RE: Volvo Recall 218
Certain Model Year 2010 - XC60

VOLVO				TITLE:		GROUP:		NO:	
				Recall 218: Fuel Line Rail Cover Inspect / Reattach		23		218	
Service Manager Bulletin						Model Year 2010 - XC60		ISSUING DEPARTMENT:	
				Warranty					
Service Personnel: read and initial.				REFERENCE BULLETINS:		CARMARKET:			
						United States, Canada			
SERVICE MANAGER		SERVICE WRITER		WARRANTY ADMINISTRATOR		DATE:			
						YEAR MONTH DAY			
						2009 12 17			
						Page 1 of 2

Retailer Technical Journal 22278

"Fuel Line Rail Cover Inspect / Reattach"

Inspect clips on front of fuel rail cover.

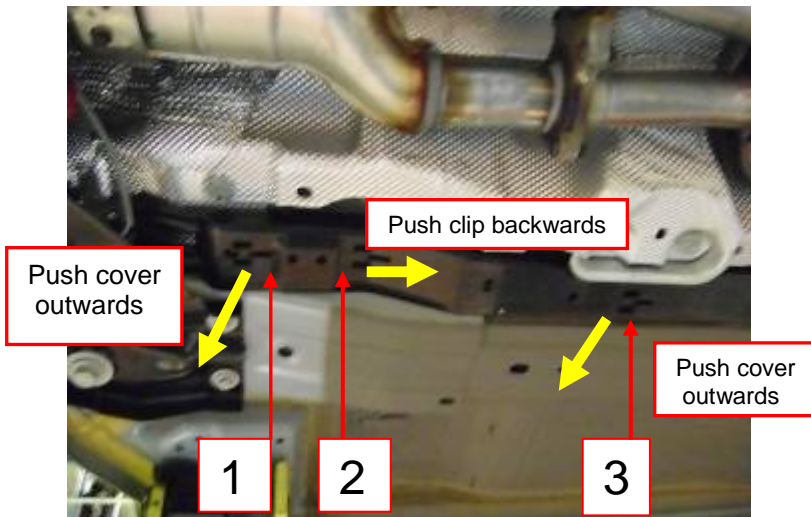
Check for loose clips by gently pulling down.

If clip 1 is not secure push the rail outwards to align over body stud.

If clip 3 is not secure push the rail outwards to align over the body stud.

Final Inspection: be sure the cover is attached at all locations and firmly held in place.

Repositioning clip 2.

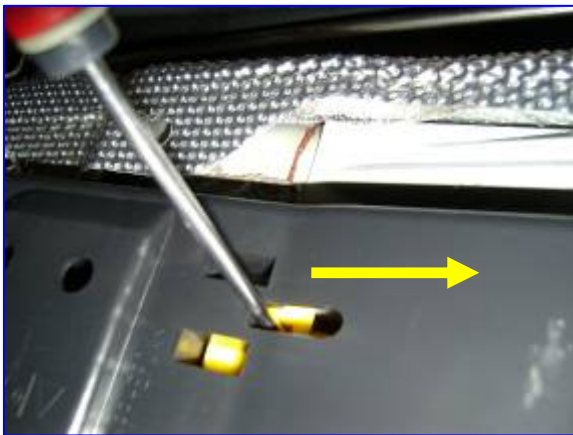
If clip 2 is not secure slide clip (not cover) backwards to align over body stud.(see pic.below)

NOTE: Bold arrows show direction of alignment.
